Revision History

## Schematics taken from P151-A00-X24 MS-8889 00A

## 1.c NV28 .. PLL / DAC / I2C

<b>©</b>		NVIDIA Corporation 2701 San Tomas Expressway Santa Clara, CA 95050, USA								
NVIDIA		NV28PL / DAC / I2C								
		Size	CAGE Code		DWG NO				lRev	
		Custom							- 1	
Tuesday, August 20, 2002		Scale		F	151-A00-X04	Sheet	3	of	18	
1

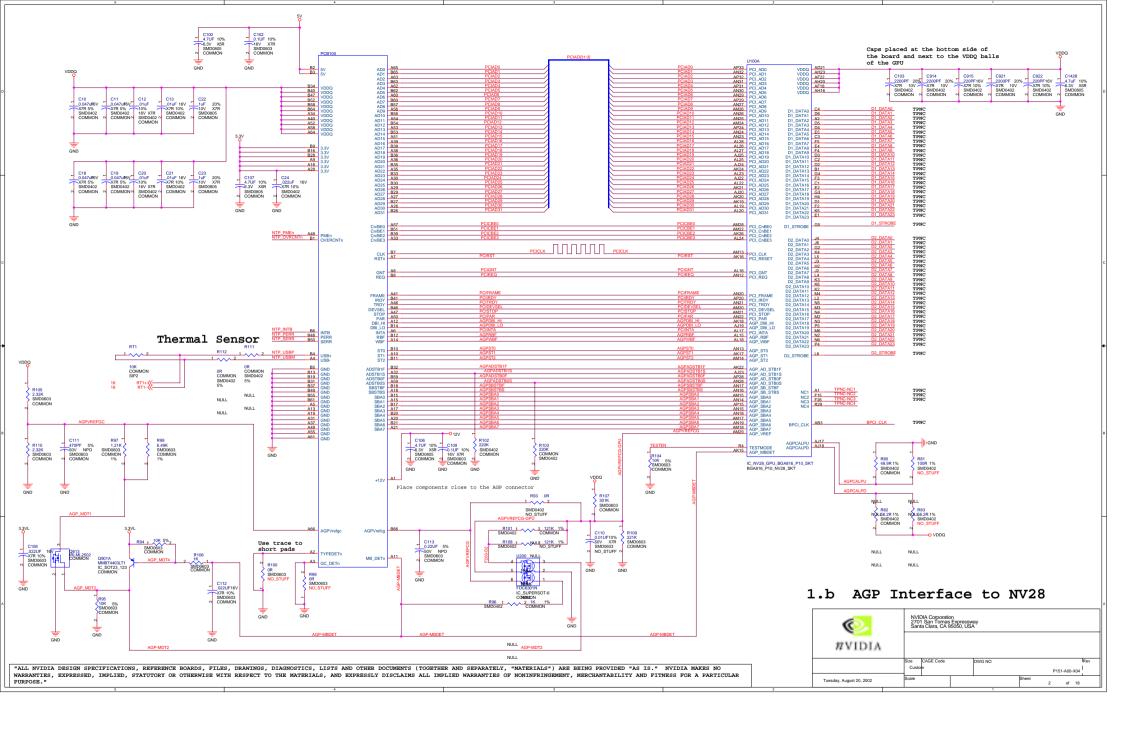
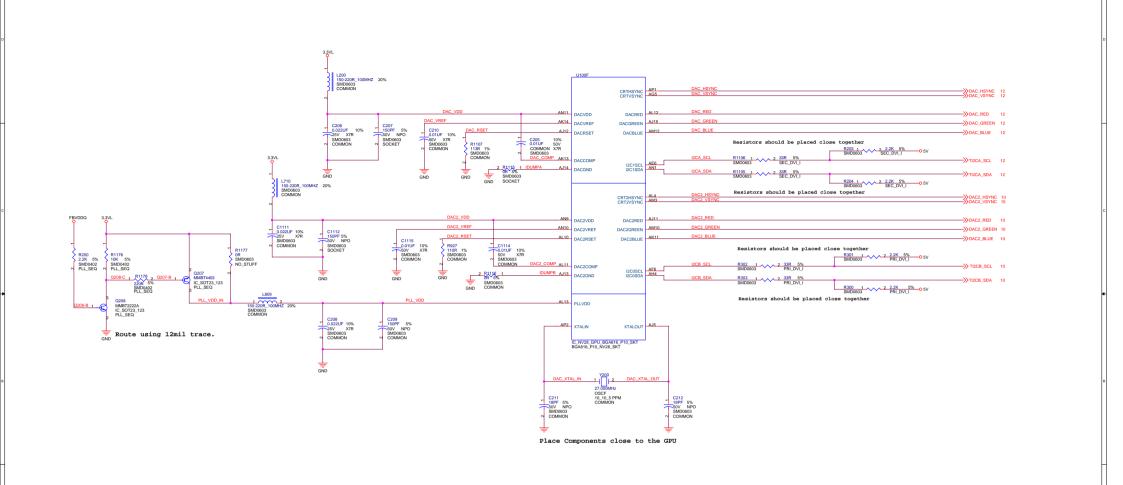
2)Page 16,17 - L801,L802 change Footprint to CHK\_3052\_08. 3) Page 3 - change P1107 to 113P and change P927 to 110P
